Subject: signed copy for Daniel Milliken Town planner-20 Fisher St Balgowlah Heights 2019/0877

20 fisher st Balgowlah Heights DA2019/0877

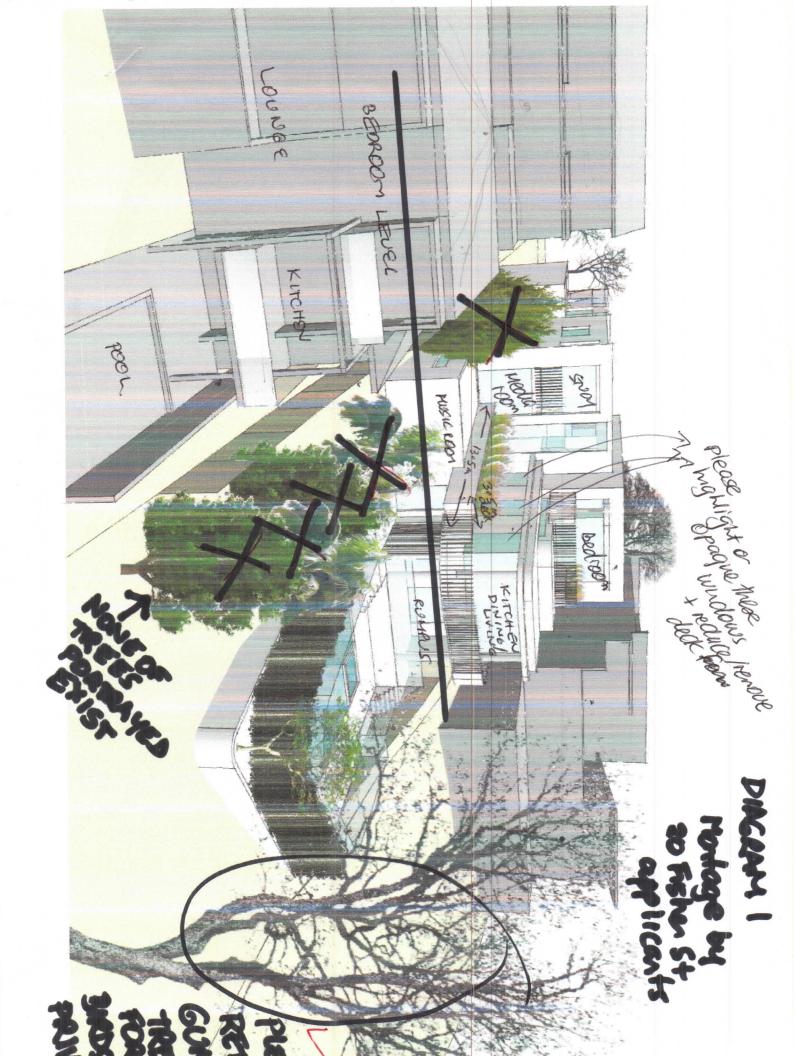
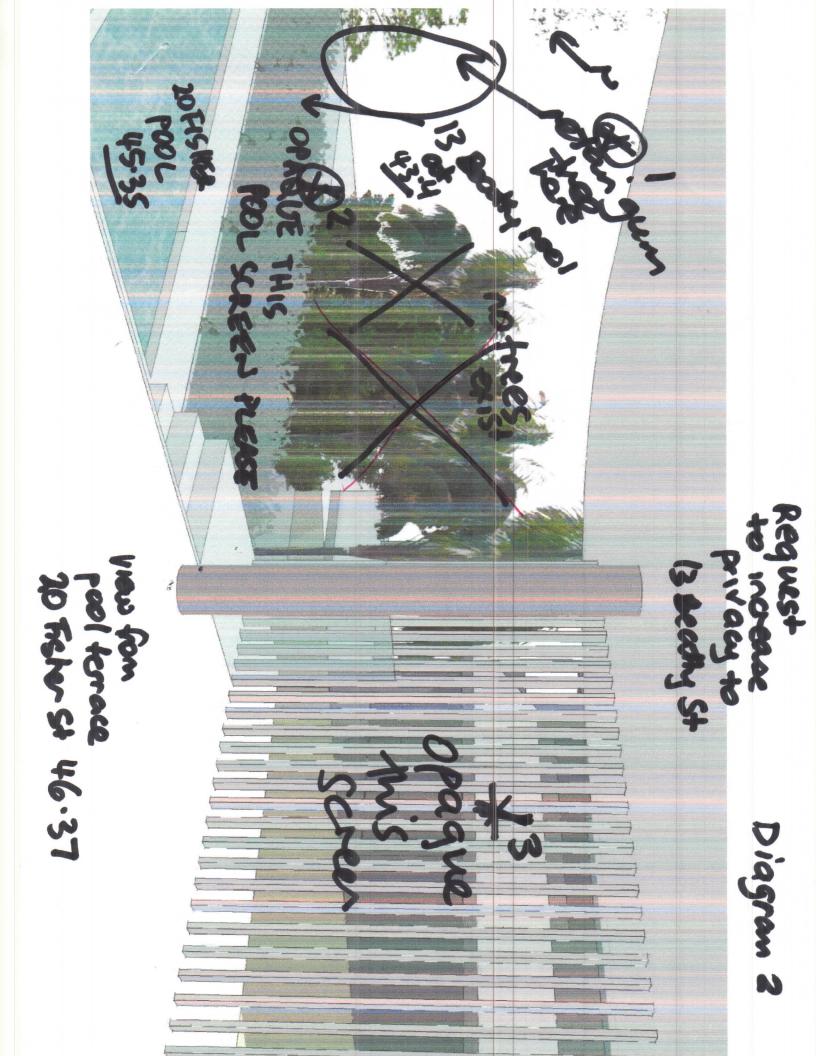
A.None of the pictured trees exist between the boundary of 20 fisher and 13 Beatty St , with the exception of the gum tree on the boundary to Beatty Street .see Diagram 1.

The gum tree circled is a haven to birds and provides some privacy to our pool which is located 2 metres below the applicants proposed pool height.

We request this gum tree be conditioned to remain and the pool screen and side terrace screen be opaque glass as our pool sits 3 metres below their pool deck .See diagram 2

The bulk and overlooking of the proposal appears to be reduced by the angle of presentation of the montage .See diagram 3.

BULK OF 20 FISHER ST (31m. PECESS FSR.)

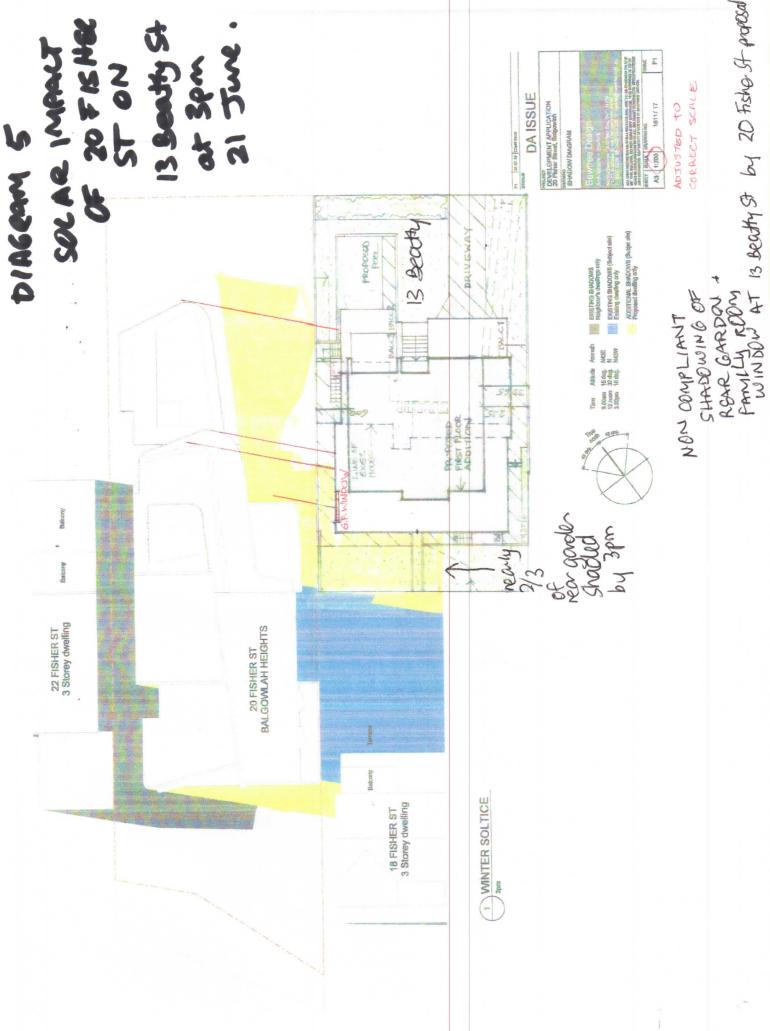
We submit diagram 4 showing the bulk of the proposal compared to our approved addition from a Beatty street perspective face on .

3. We have read the Appendix B clause 4.6 submission by Vaughan Milligan applying for an excess FSR of 37 m2 or 8.7 per cent more above the 388 m2 permissible. It is the excessive size and bulk of the building that is effecting our amenity as neighbours causing the solar and privacy issues.

DIAGON 7 DECK &

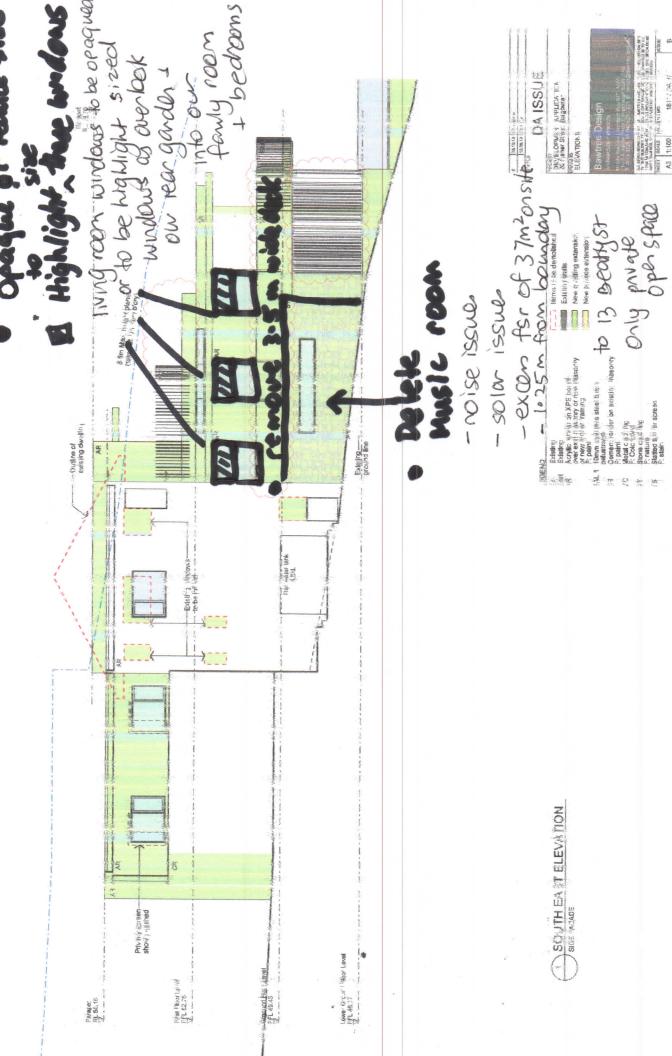
3. It is unreasonable that an approx 45m 2 deck c.3.5 m wide by 13 m long coming off the kitchen / living area with 3 large windows floor to ceiling faces us just 5 m from the side boundary and 1 metre above our bedroom floor level .. See diagram 6,7,8.

We request this deck be deleted and living room windows be made highlight size . This would be in line with new highlight windows we have provided from our approved renovation facing 20 Fisher Street.
